Project Address: 22 South Carroll Street (4th Aldermanic District, Alder Verveer)

Application Type: Conditional Use

Prepared By: Heather Stouder, AICP, Planning Division
Report Includes Comments from other City Agencies, as noted

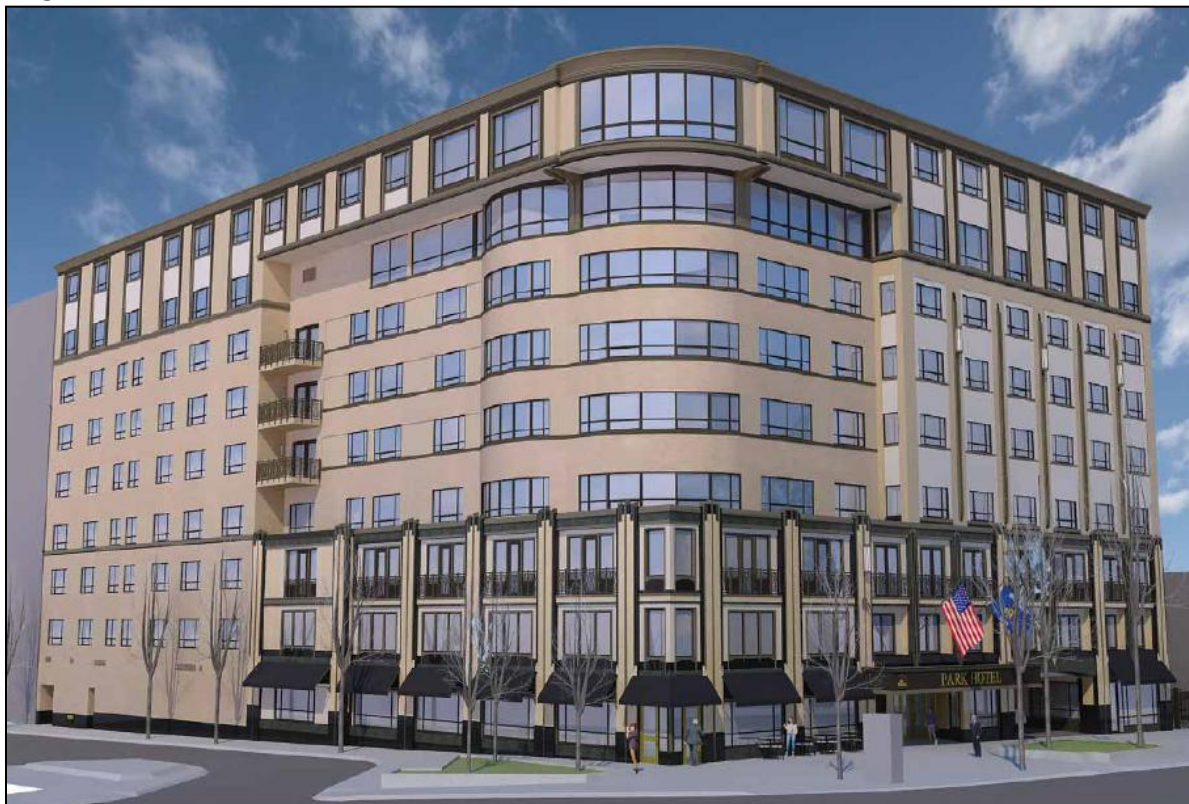
Following the January 14 referral of this proposal by the UDC, the applicant made exterior architectural revisions to address their concerns (see comparison on following page). In order to simplify the building and improve overall cohesiveness, vertical elements originally proposed on the Carroll side of the building (right side on the renderings) have been removed. Also, lighter colored EIFS panels have been added between windows on the Mifflin side of the building (left side on the renderings). The design details on the base of the building have been simplified, but with the same palette of materials – granite and limestone. The parapet has been slightly raised to accentuate the top of the building.
